ALERT SERVICE BULLETIN

NO. 407-10-93

MODEL AFFECTED: 407

SUBJECT: TAILBOOM ATTACHMENT HARDWARE,
REPLACEMENT OF.

FIGURE 1: Maximum and minimum reference dimensions of socket

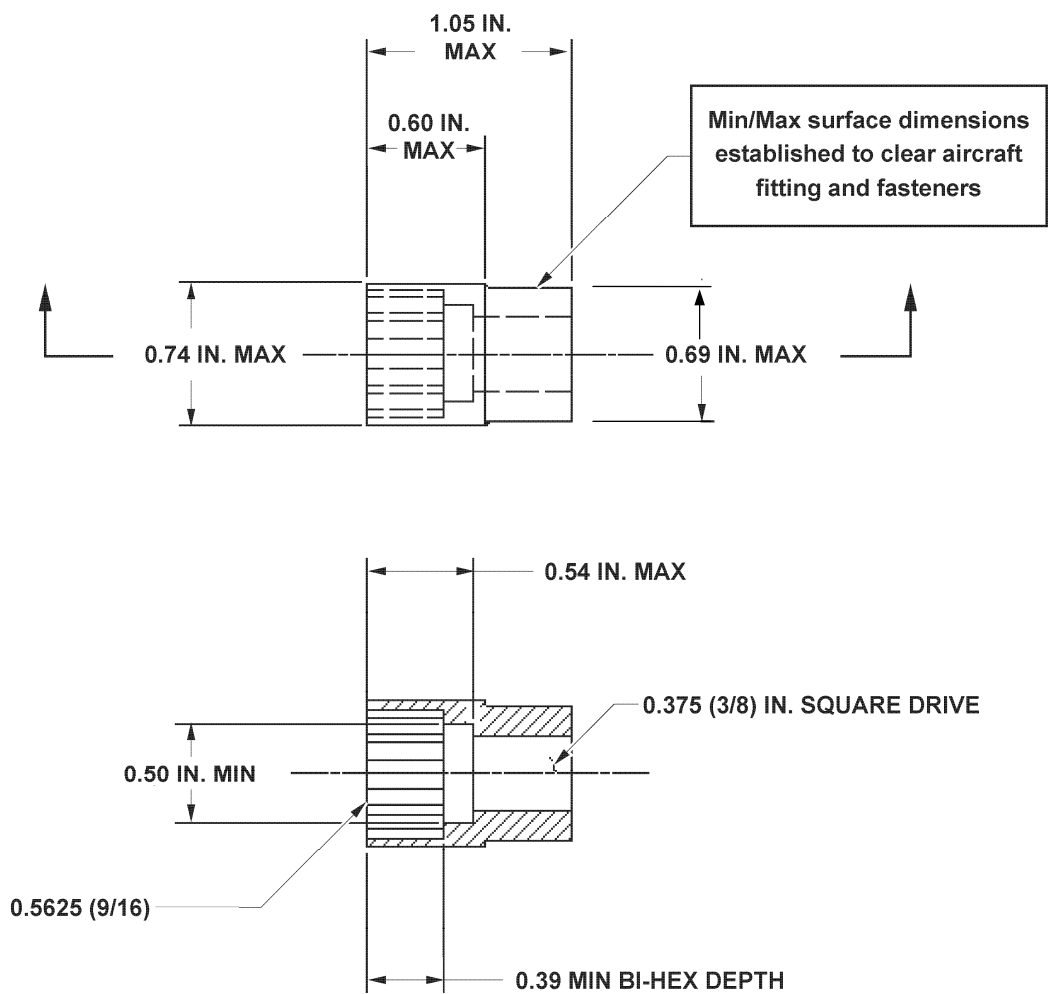
Note: an equivalent tool may be locally fabricated using a commercial 12-point socket. Refer to Figure 1.

Socket P/N 407-230-001-101 or equivalent

FIGURE 2: Replacement of tailboom upper attachment bolts (Sheet 1 of 2)

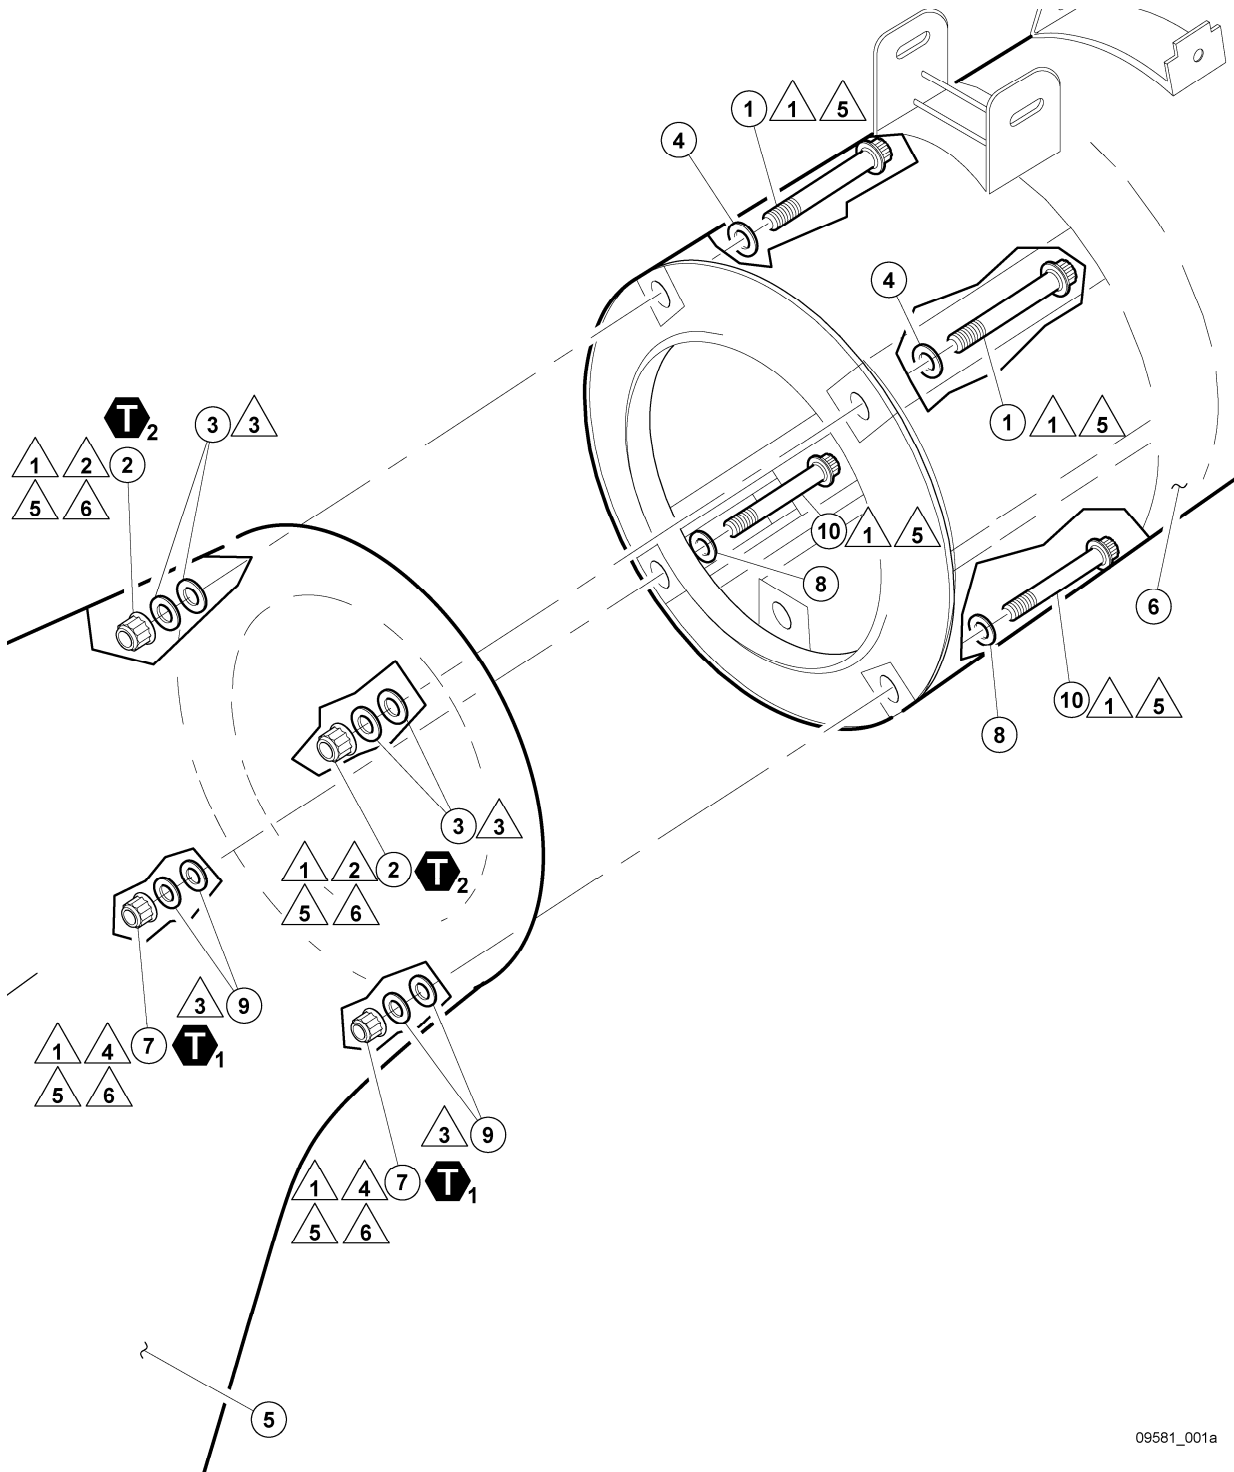
Bell Helicopter has reviewed the tailboom attachment installation of the Model 407. It has been determined that the torque values specified in the maintenance manual and used during assembly of the 407 for the tailboom attachment bolts exceed the specified torque range recommended for subject bolts.

This bulletin mandates the removal of the existing tailboom attachment hardware and the installation of new hardware with reduced torque values. In addition, specific hardware installation/torquing procedure is provided for the tailboom to aft fuselage joint.

1. (Ref. Figure 2) Remove left upper attachment bolt (1) and nut (2) but retain the chamfered washer (4) and the regular washers (3). Discard the nut (2) and the bolt (1) you have removed.

5. (Ref. Figure 2) Remove left lower attachment bolt (10) and nut (7) but retain the chamfered washers (8) and the regular washers (9). Discard the nut (7) and the bolt (10) you have removed.

For torque check purposes, the assembly torque to be applied is the minimum specified torque (see Figure 2) plus the minimum acceptable tare torque of 14 inch/lbs(1.58 Nm) for the upper nuts (2) and 9.5 inch/Lbs (1.07Nm) for the lower nuts(7).

1 360 TO 370 INCH/LBS
(40.6 TO 41.8 Nm)

2 570 TO 580 INCH/LBS
(64.4 TO 65.5 Nm)

-  1 Replace existing bolts and nuts by new ones.
-  2 Upper nut must have tare above minimum value of 14 inch-pounds (1.58 Nm).
-  3 Adjust quantity of washers to obtain proper safety of nut in accordance with maintenance manual.
-  4 Lower nut must have tare above minimum value of 9.5 inch-pounds (1.07 Nm).
-  5 Replace nuts and bolts each time the tailboom is disconnected from the fuselage.
-  6 Torque nut to indicated value then back off nut a minimum of 3/4 of a turn before retorquing again.
7. Perform torque check 1 to 5 hours after initial installation. Repeat this torque check at repetitive periods between 1 to 5 hours until torques stabilize at all 4 locations.
8. Perform torque check of all hardware every 300 hours of component operation.
